# CONCURRENCE POINT 2 UPDATE ALTERNATIVES TO BE STUDIED IN DETAIL

I-26 Interchange (Future Exit 35)  
Buncombe County  
STIP Project HE-0001  
WBS No. 49742

September 16, 2021

**EXHIBIT 1. PROPOSED PROJECT ROADWAY TYPICAL SECTION (PROPOSED 4-FOOT PAVED, 4-FOOT GRASSED SHOULDER)**

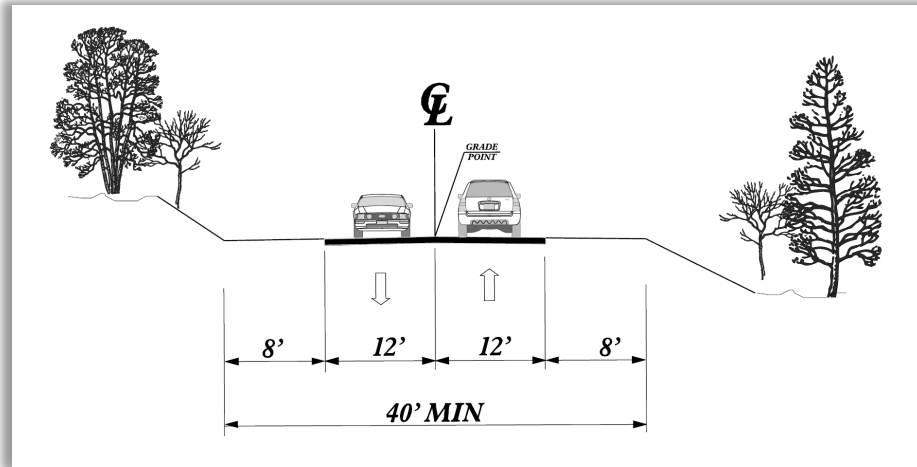
Based on the Traffic Forecast and preliminary traffic analysis, NCDOT has determined that a 2-lane shoulder typical section for the proposed project roadway will accommodate the projected traffic volumes (19,500 AADT in 2045 Build) (**Exhibit 1**). Auxiliary lanes (e.g., turn lanes, slip lanes) will be evaluated and included in preliminary designs for proposed intersections to facilitate traffic operations.

Figure 2

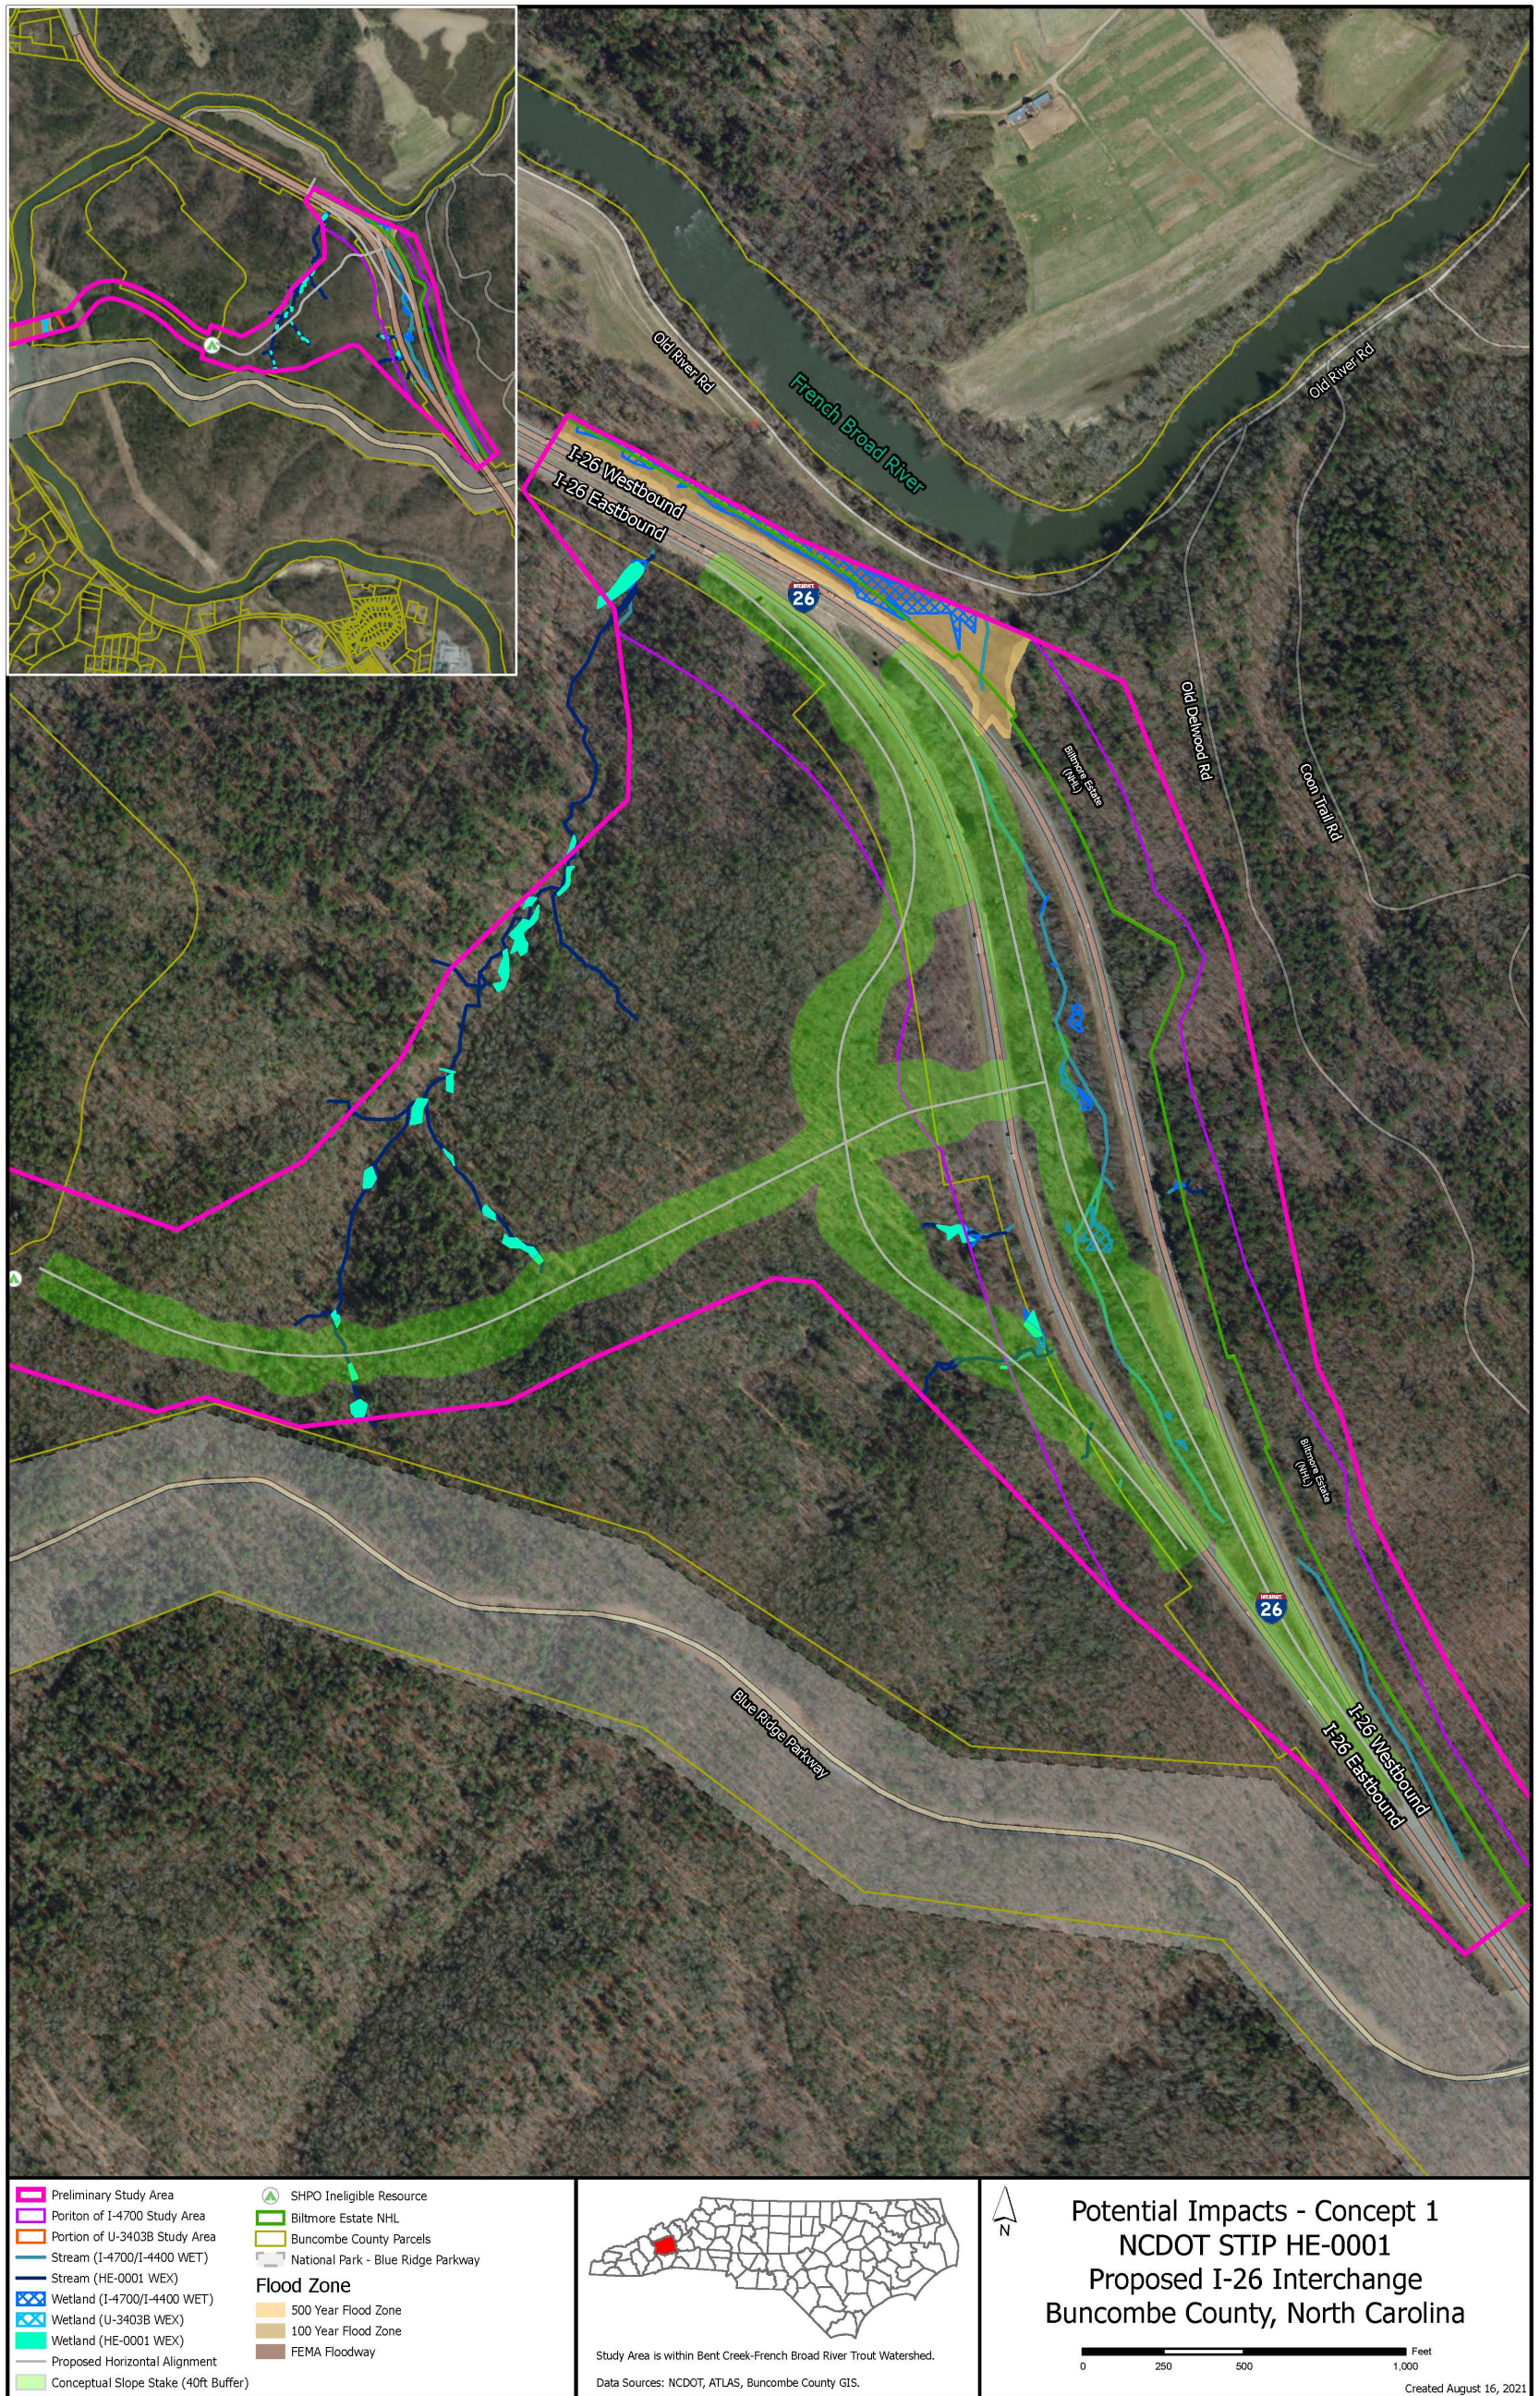
<b>Table 4. Potential Impacts for the 2-lane with Shoulder Typical Section*</b>				
		<b>Alternative 1</b>	<b>Alternative 2</b>	<b>Alternative 3</b>
Figure No.		2	3	4
Streams <sup>+, ^</sup> (ft)		2,300	2,200	1,400
Wetlands <sup>+</sup> (ac)		0.3	0.2	0.1
FEMA Floodplain (ac)	Floodway	0	0	0
	100-Year Floodplain	< 0.1	0.2	0
	500-Year Floodplain	< 0.1	0.4	0
Biltmore Estate NHL (ac)		0	6.8	0
<p>*Conceptual design slope stakes plus 40 feet with a 2-lane shoulder typical section for the proposed roadway.</p> <p>+ These potential stream and wetland impacts exclude I-4700 permitted impacts.</p> <p>^The HE-0001 PJD delineated to active construction limits or control of access (C/A) fence resulting in some overlap with the I-4700 PJD. In these cases, the HE-0001 (i.e., more recent) delineation was used and the I-4700 PJD feature removed from potential impact calculations. This overlap did not affect the I-4700 PJD in the bifurcated section of I-26.</p>
